## **Proposal for Supplement 17 to the 00 series of amendments to Regulation No. 38 (Rear fog lamps)**

### **Submitted by the expert from Germany\***

The text reproduced below was prepared by the expert from Germany updating the Conformity of Production requirements (CoP). The modifications to the current text of the UN Regulation are marked in bold for new or strikethrough for deleted characters.

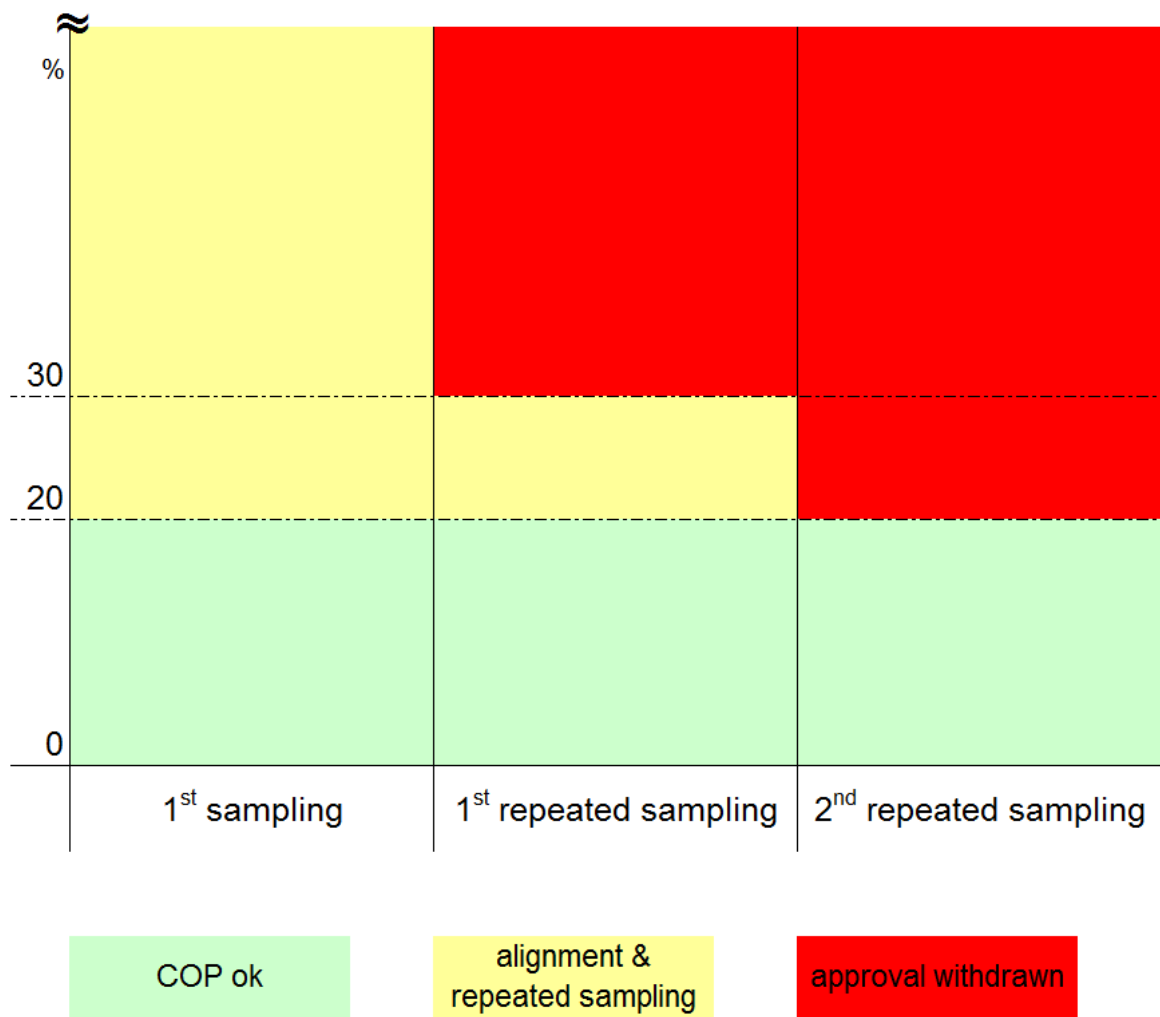
6. CoP is now described in a clear structured stepwise process (with limited steps), which gives the manufacturer the chance in the first step - in the case of deviations of more than 20 per cent - to align his production process. Also, the CoP process can be completed earlier when the first two samples are in the full specifications.

7. The proposal details the "third step" which defines the condition where the approval shall be withdrawn, when after the second repetition of this process the manufacturer was not in the position to "align" his production process in the correct way.

8. The attached drawing shall demonstrate this stepwise process.
